Architectural Review Board Staff Report

Project Type: Amended Architectural Elevations

Meeting Date: May 14, 2015

Description: Clarkson Square, Lot 2: Amended Architectural Elevations and Architect's Statement of Design for an 8.25 acre tract of land zoned "C-8" Planned Commercial District located on the north side of Baxter Road, west side of Clarkson Road.

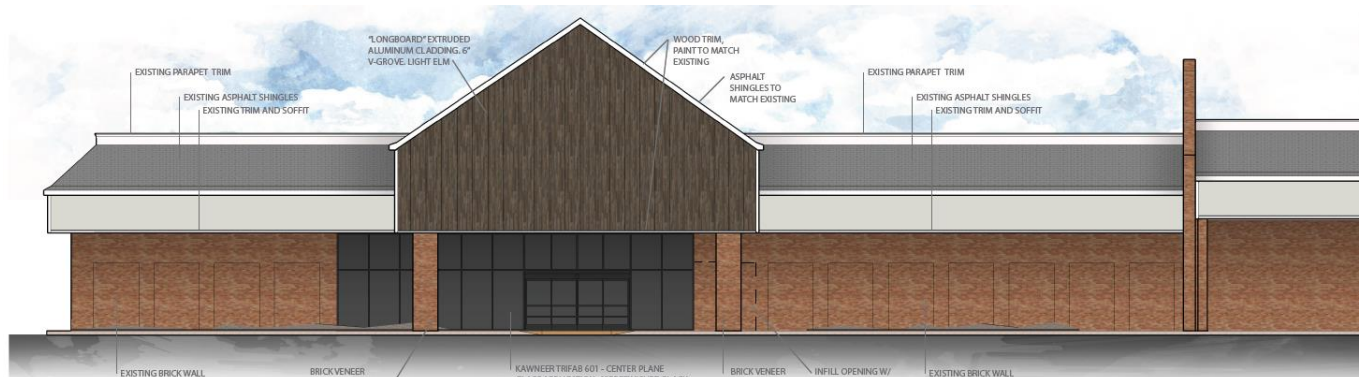
Signage is not part of the proposal before Architectural Review Board and will be reviewed by Staff. However, the proposed peak roofline will increase the vertical façade of the building and thus the opportunity for wall-mounted signage.
